**Carrie Scoville 415 W. Elberon Avenue San Pedro California 90731**

Re: **Public Comment**  
**Recirculated Draft EIR – Berth 97-109 Container Terminal Project, April 2008**

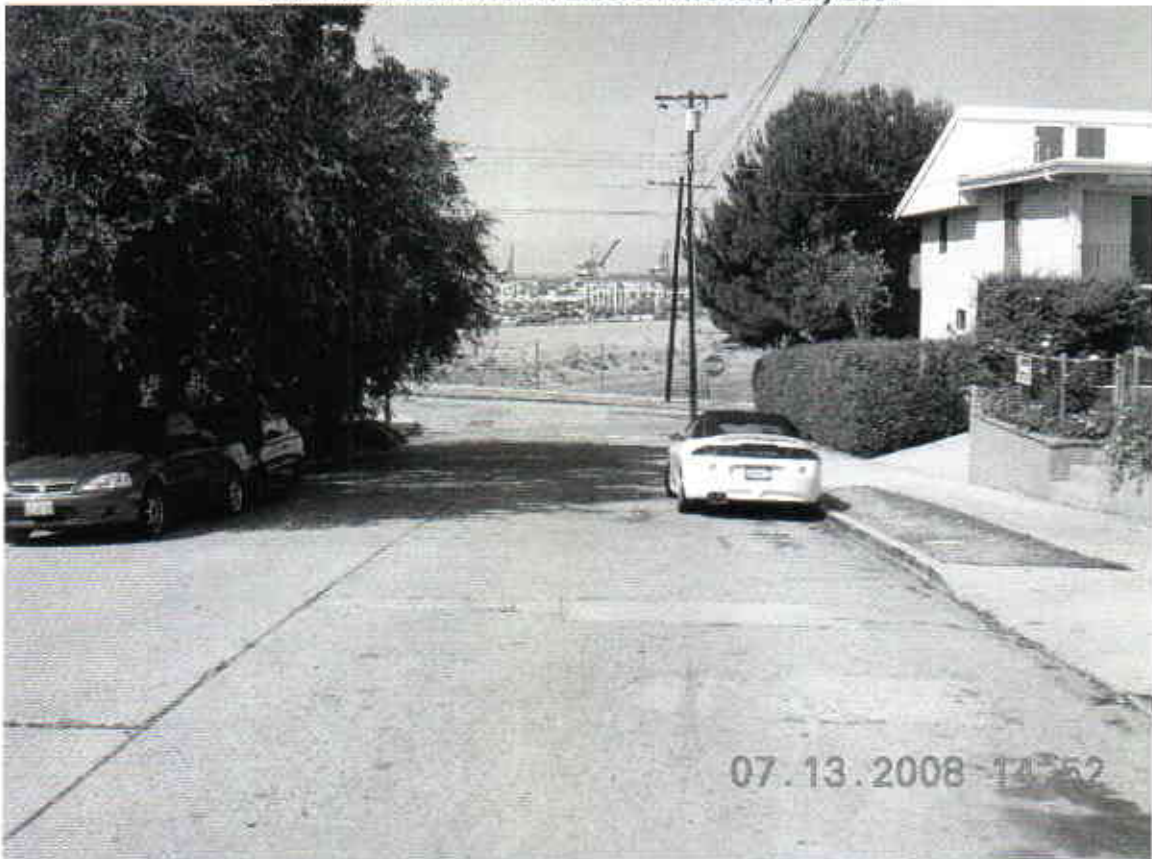
1. The EIR is deficient in identifying the aesthetic impacts of this project in that it only describes the visual impact of additional cranes at the terminal. However, the entire project is dependent upon the 45 acre fill in Southwest Slip constructed in 2001-2003 (concurrent with this project) as part of the Channel Deepening Project. The aesthetic impacts of that fill are excluded from this EIR. Since this China Shipping project includes developing this same fill site for terminal backlands establishing a “footprint”, and it commenced within the same timeframe (2002), I am including its associated environmental impacts in this comment document. To consider the Southwest Slip fill as a separate project would constitute “piece-mealing” or project linkage.
